NOTICE OF A TYPE II DECISION ON A PROPOSAL IN YOUR NEIGHBORHOOD

CASE FILE NUMBER: LU 10-109220 AD

Proposal: The applicant is proposing to demolish his existing garage and replace it with a 2-story detached accessory dwelling unit (ADU). To address applicable Zoning Code development standards, the applicant is requesting: (1) a reduction in the required side (south) building setback from 5 feet to 3 feet, 7 inches, with a 1 foot, 8 inch eave overhang and (2) to allow the roof pitch of the proposed ADU structure to differ from the pitch of the house.

LU 10-109220 AD
Exhibit C.1

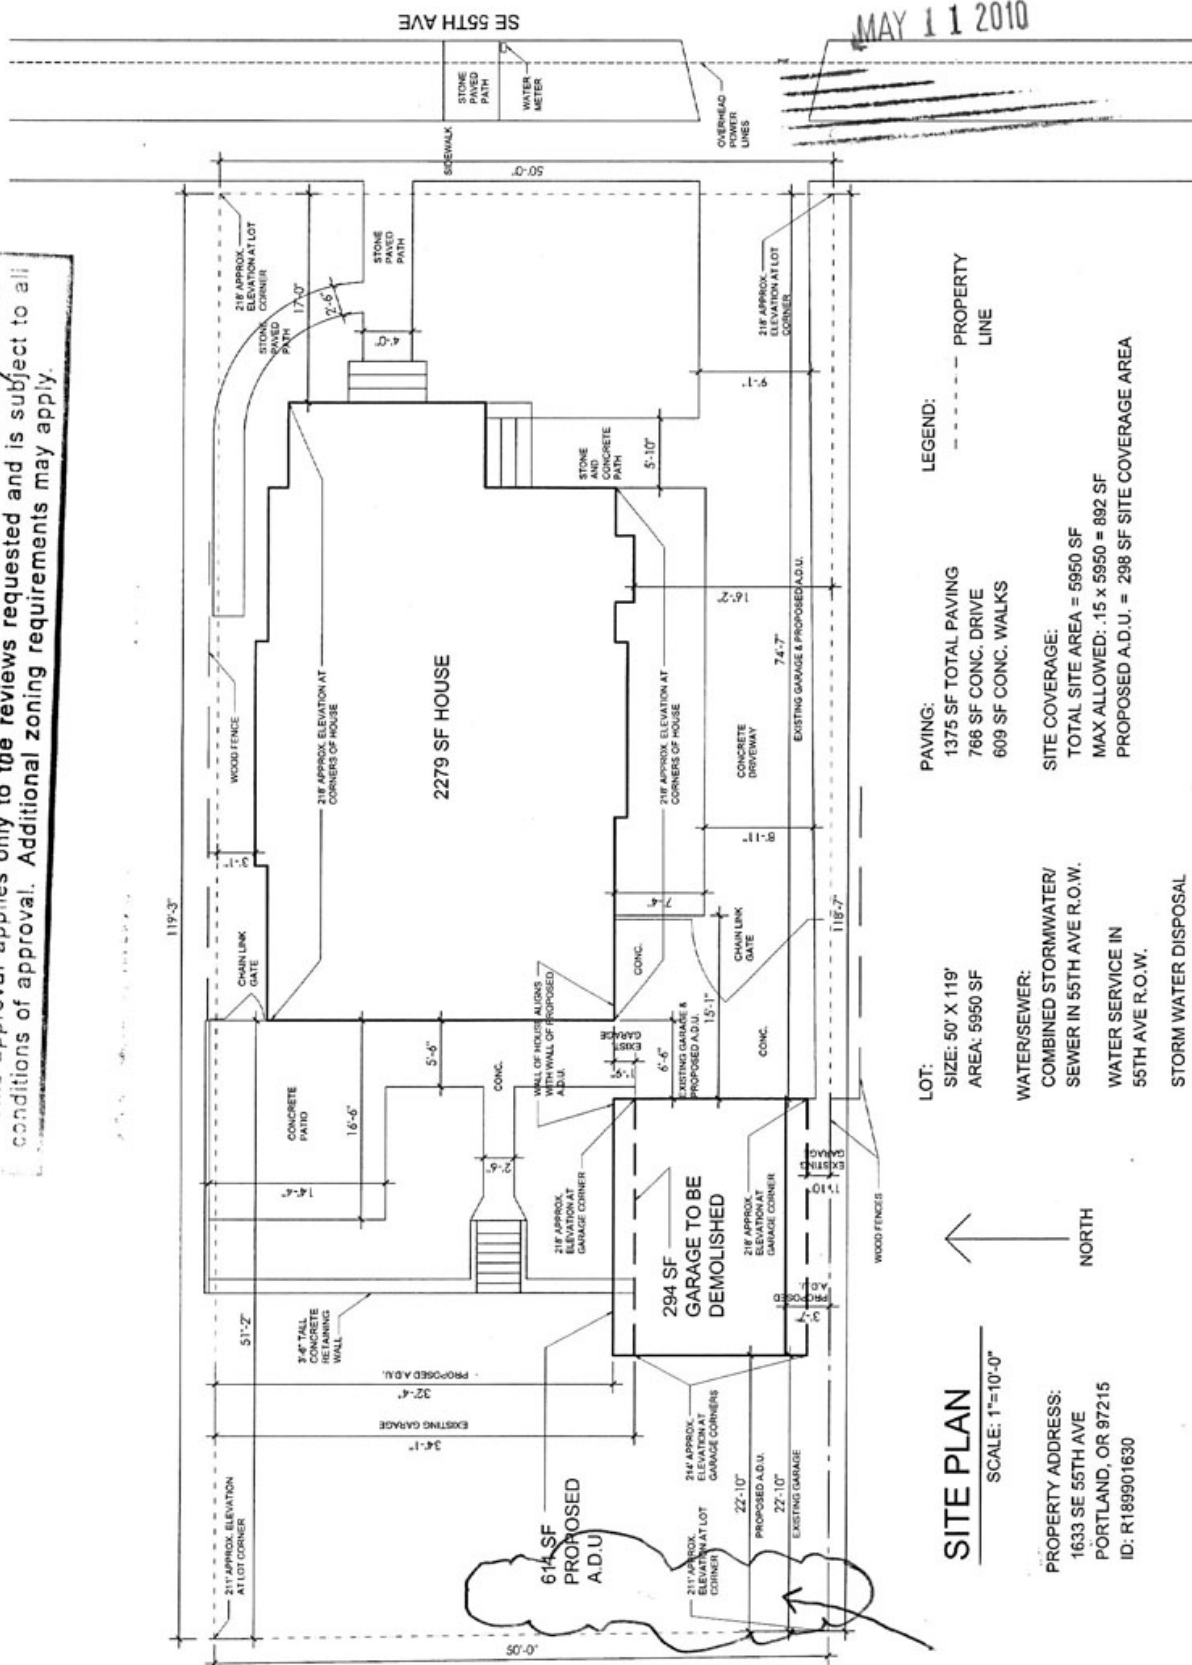
topography of the site. The variation in roof pitch (and direction) will be clearly visible. To mask the difference in appearance, a condition will require the applicant to install 2 deciduous or broadleaf evergreen trees, selected from the Portland Tree and Landscaping Manual. The trees must achieve a canopy spread of at least 30 feet. The trees must be planted at least 5 feet from property lines, located between the ADU structure and the western property line and must be located within the southern half of the site.

2 trees are required

- A. As part of the building permit application submittal, the following development-related conditions (B through D) must be noted on each of the 4 required site plans or included as a sheet in the numbered set of plans. The sheet on which this information appears must be labeled "ZONING COMPLIANCE PAGE - Case File LU 10-109220 AD." All requirements must be graphically represented on the site plan, landscape, or other required plan and must be labeled "REQUIRED."
- B. At least 2 deciduous or broadleaf evergreen trees must be planted between the ADU structure and the west property line. The trees must be selected from the Portland Tree and Landscaping Manual to achieve a canopy spread of at least 30 feet. The trees must be planted at least 5 feet from the property lines.

LU 10-109220 AD
Exhibit C.3

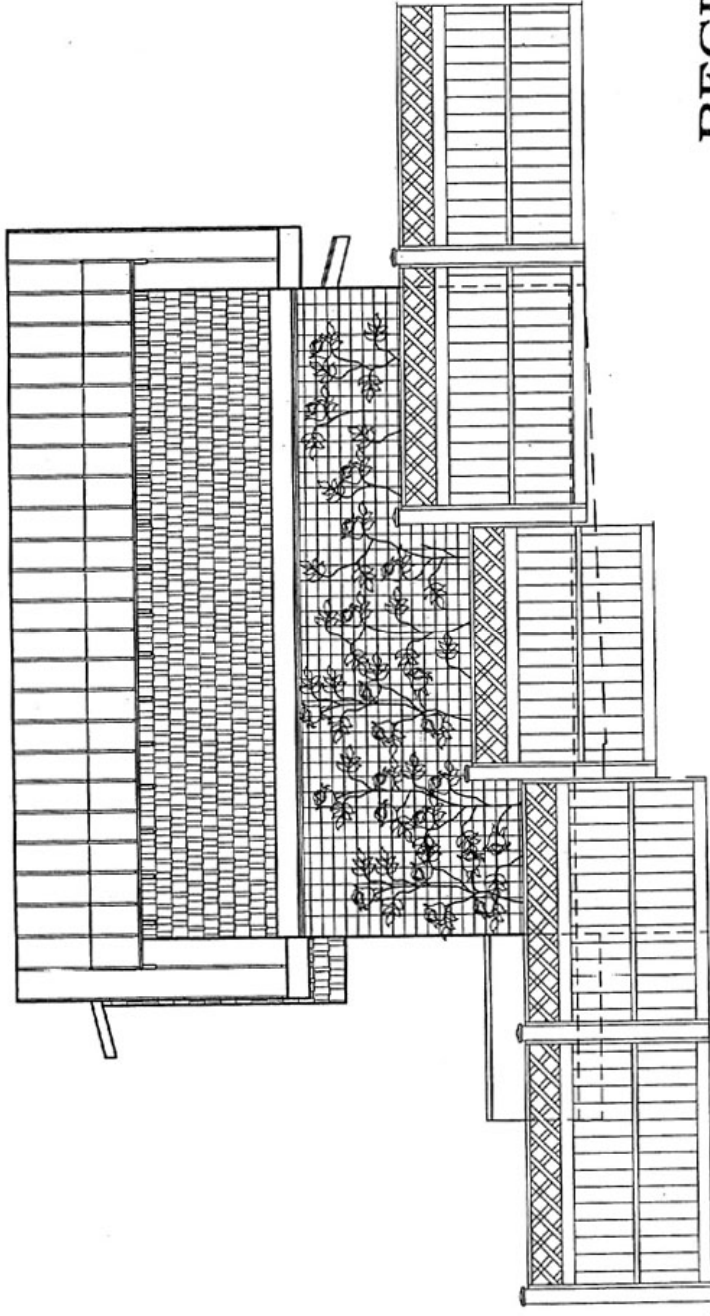
If proposed planting fully covers the south wall, only roof area will be visible from the southern abutting lots. However, there is risk in relying fully on climbing vines or other plants to create an attractive façade. In order to ensure that the structure is compatible, exterior improvements must include the same exterior treatment proposed on the other sides of the structure. Specifically, horizontal lap siding must be installed on the south wall of the accessory structure.

- C. Horizontal lap siding must be installed on the south exterior wall, to match the other sides of the ADU. The siding must be painted to match.
- D. A 6-foot tall wood fence must be installed along the south property line, per the approved plans (Exhibit C.3).
